Re-submittal Form

September 22, 2021

Re: Clear Creek Valley (Previously TTLC Denver – Lowell) – 2nd Review Comments
Project Number: PRC2021-00002

COVER SHEET
SHEET 1 OF 10

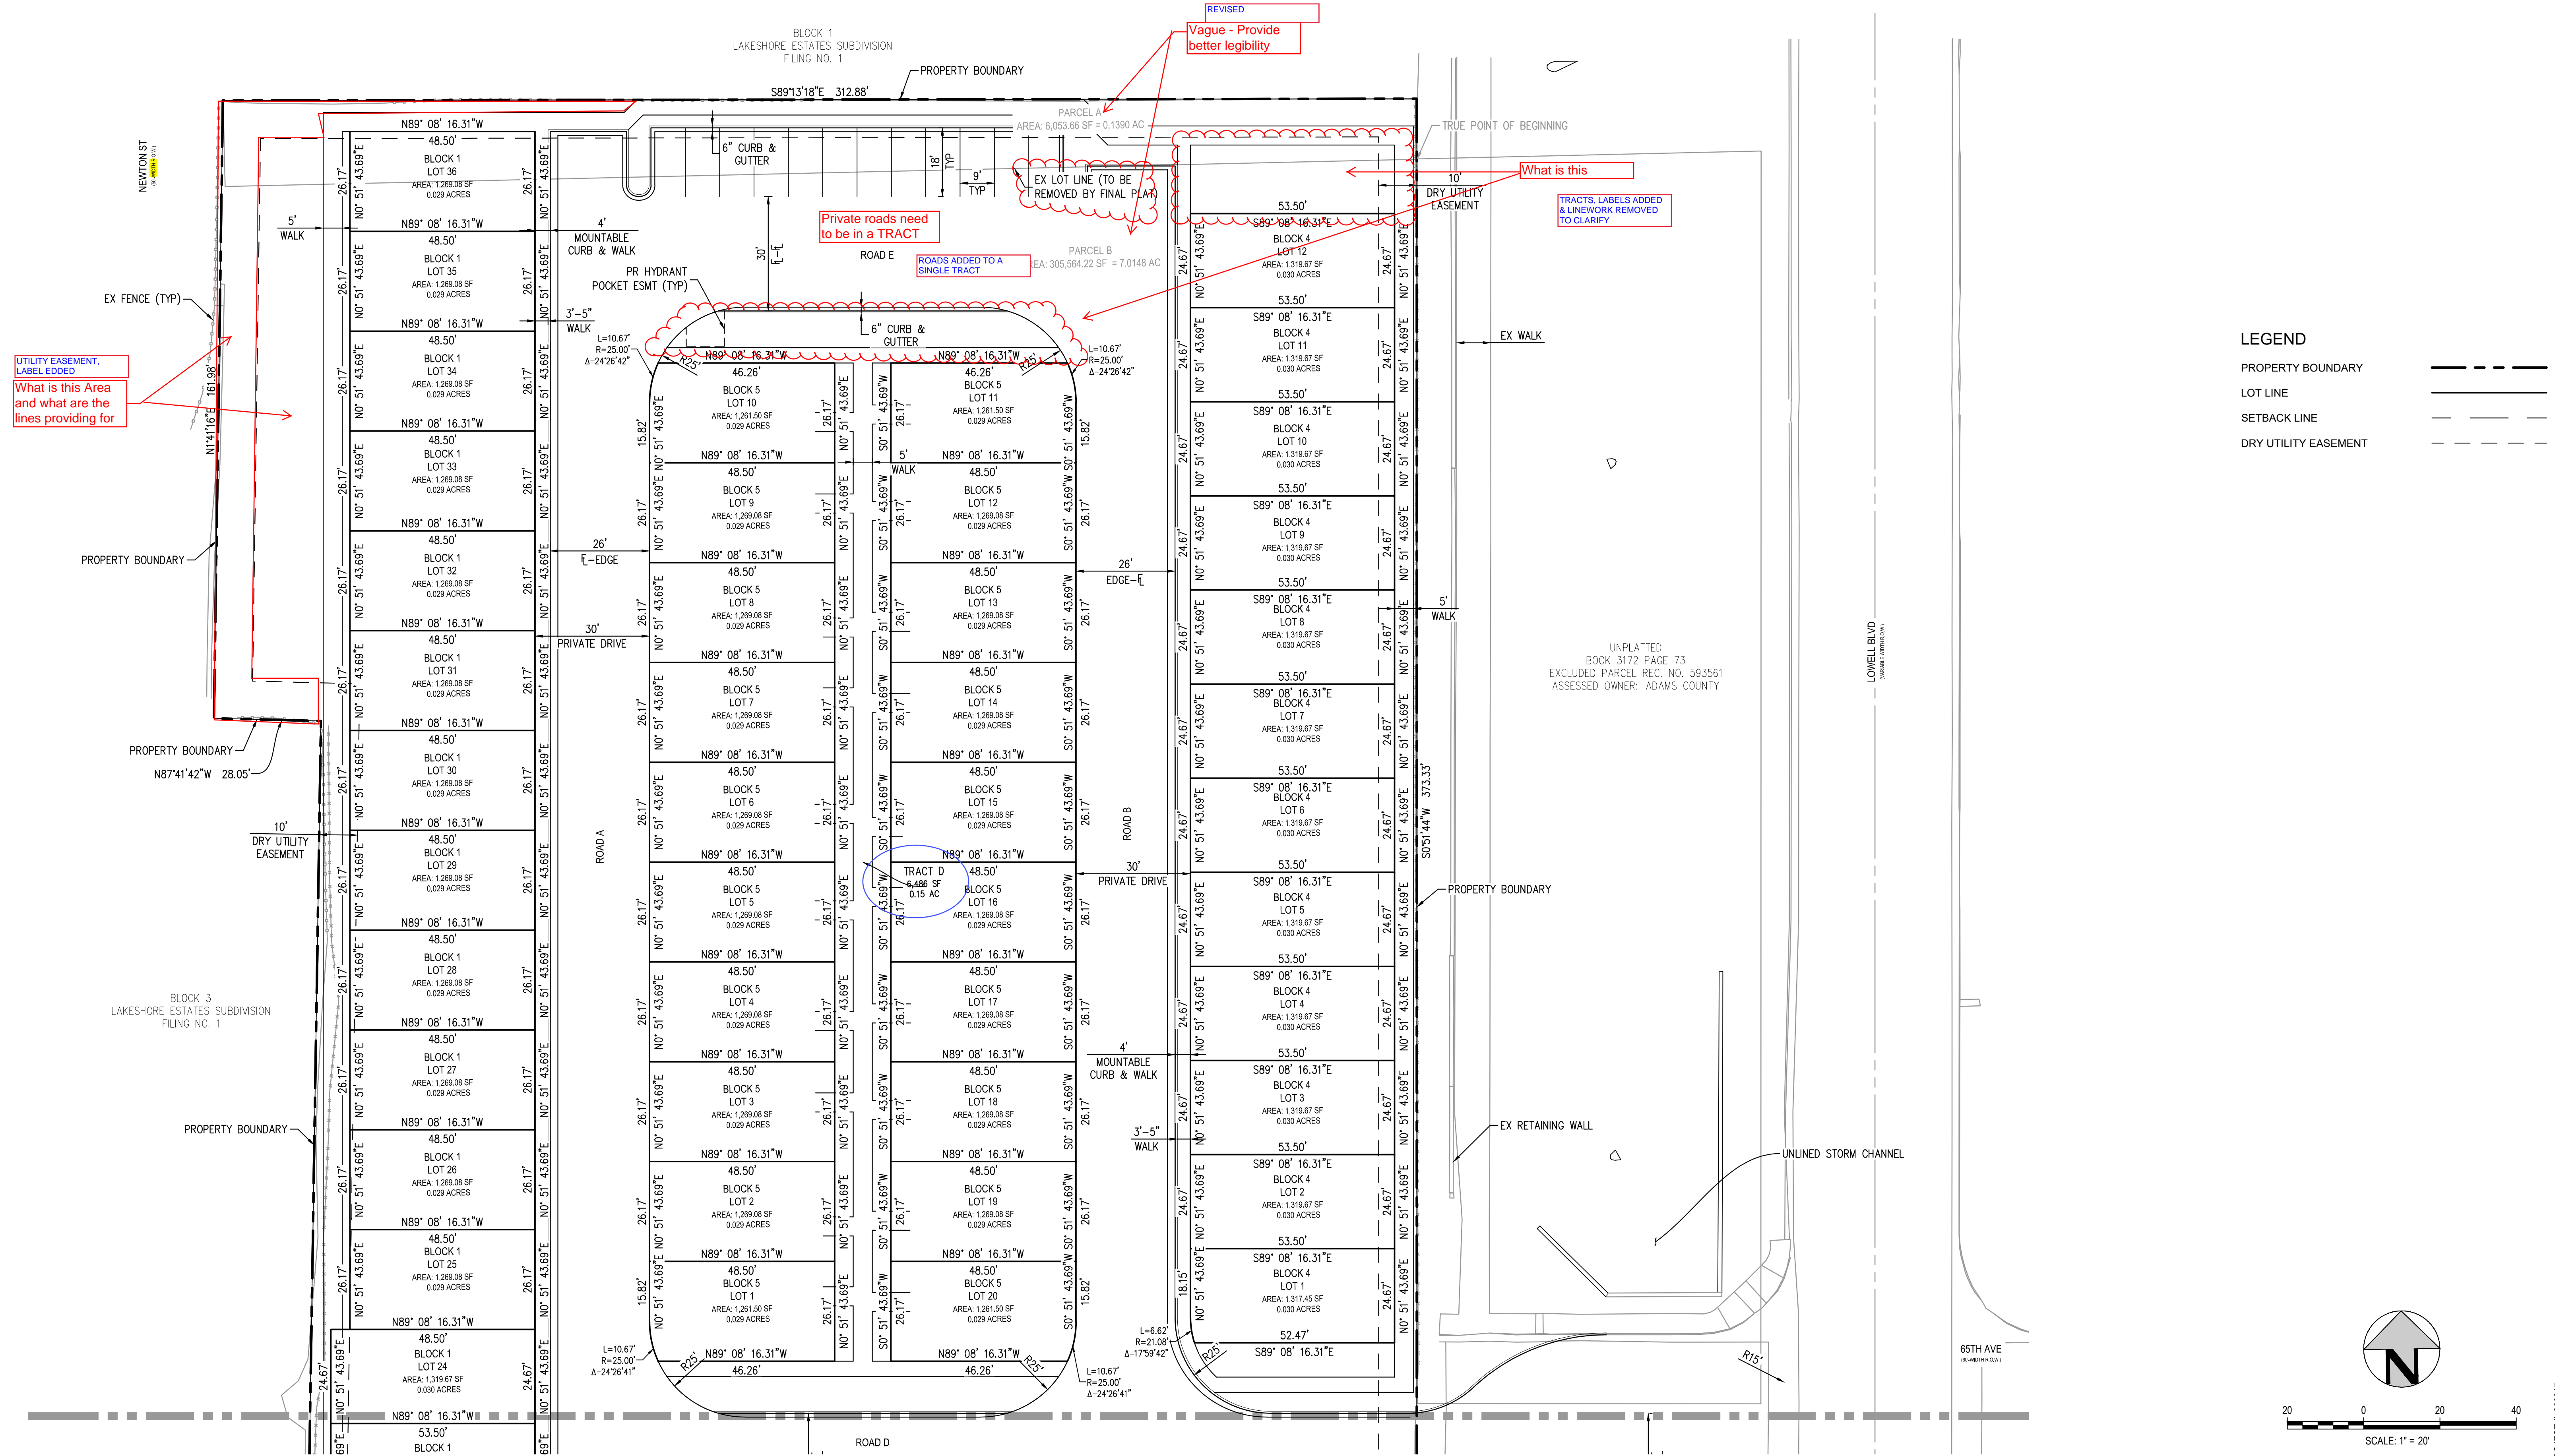
TRACT E LABELS ADDED TO PLAT	
Tract E not found shown on plat. Provide clarity

Needs to be on another sheet depending on Sheet 1 once all required information provided.

TRACT TABLE FITS ON
COVER SHEET

SHEET 11 OF 12

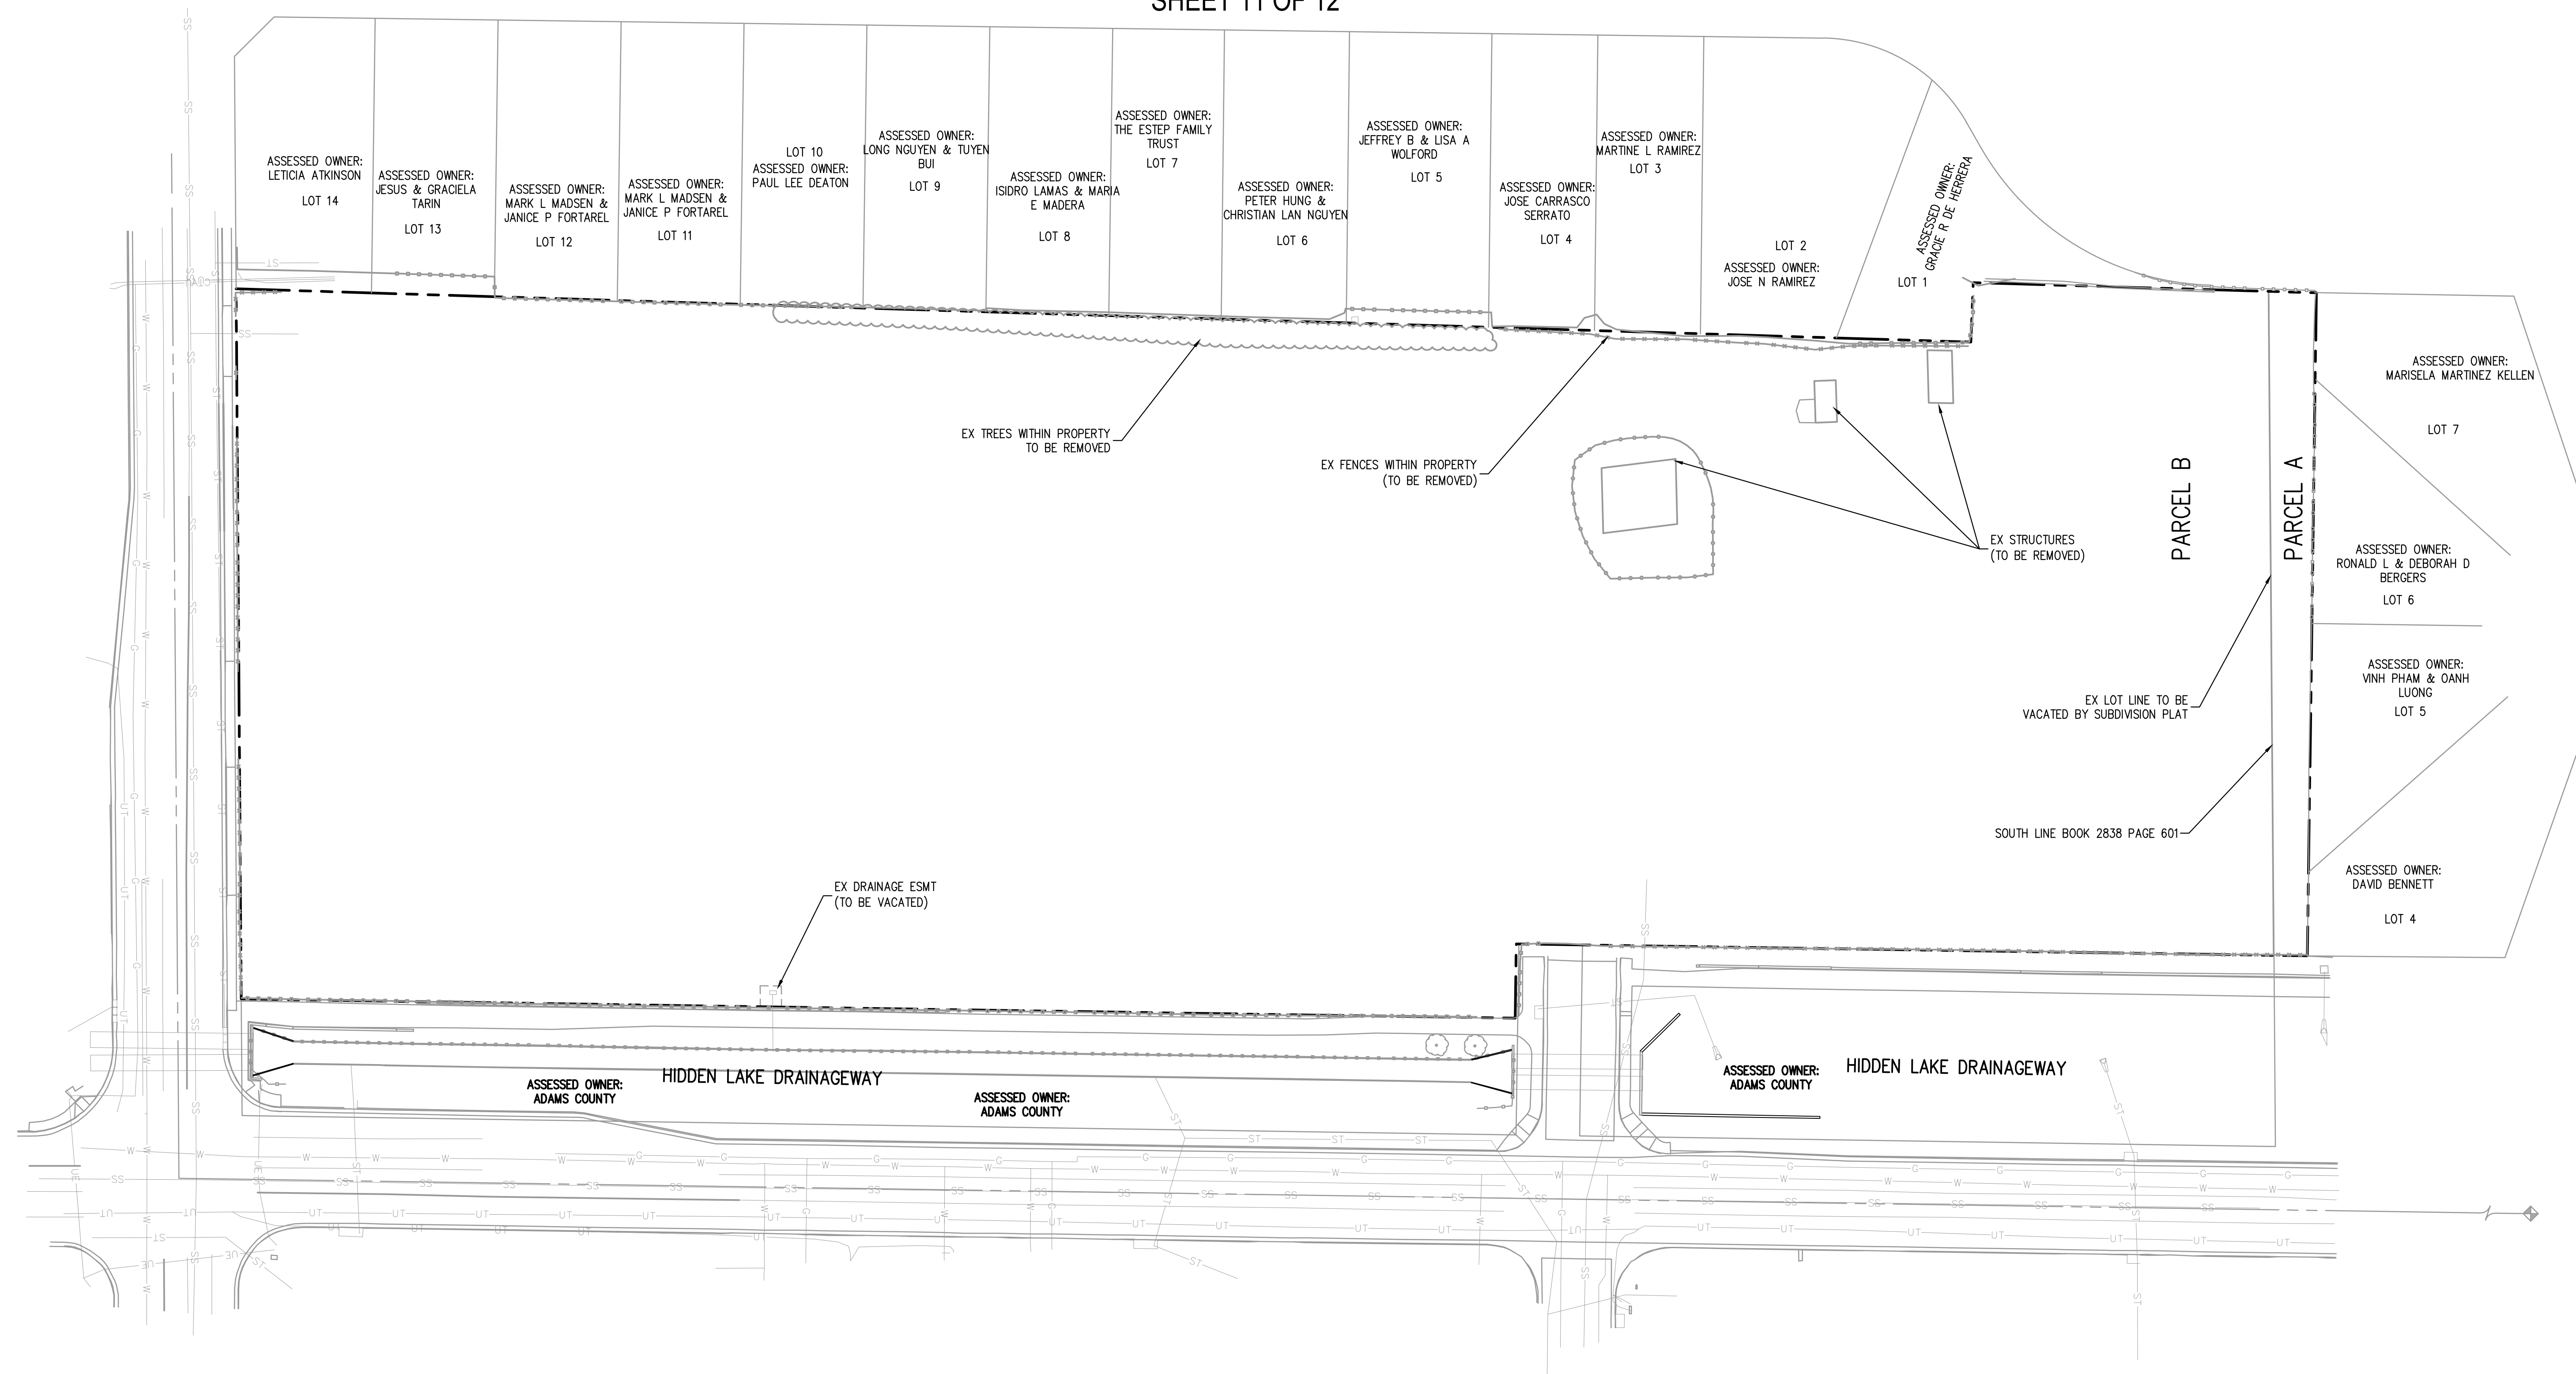
8. Provide actual dimensions for Lowell Blvd. and 64th Ave. instead of "Varies" on plats.

9. Provide location of easements within 5' of property boundary by recording information and identify any conflict of interest.

Response: Provided on Existing Conditions sheet 11 in the Preliminary Engineering Plans.

Response: Provided on Existing Conditions sheet 11 in the Preliminary Engineering Plans.

SHEET TITLE:
LOT
TYPICALS
SHEET NUMBER:

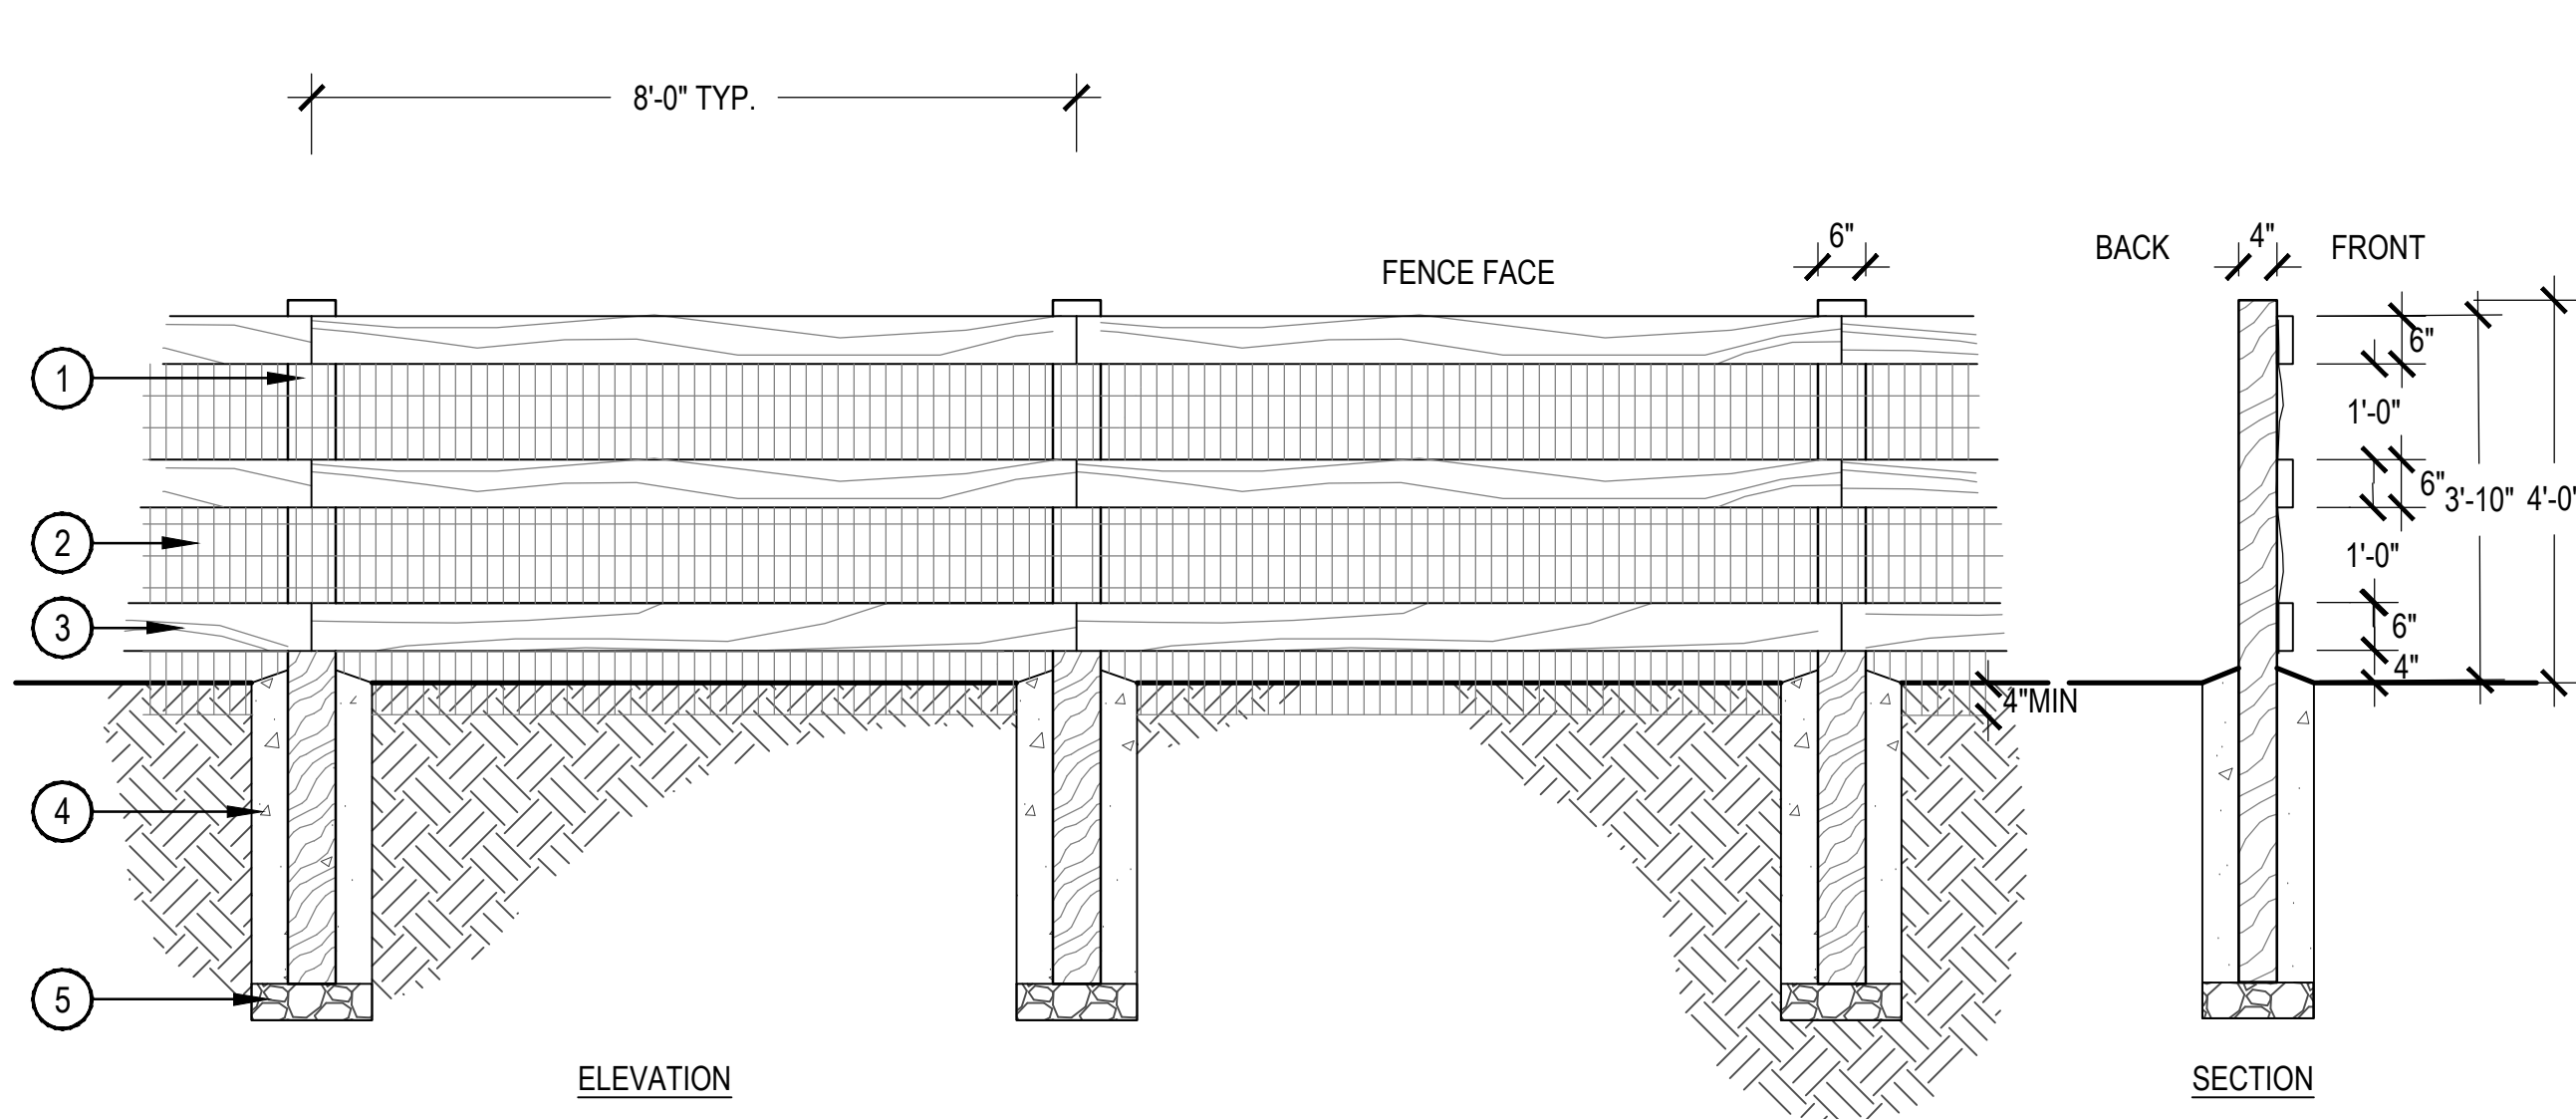
- a. Will landscaping be required per individual lot? If so, please provide a statement on this in the PDP.

Response: Yes, landscape lot typicals have been included on page 7 of this PUD/PDP.
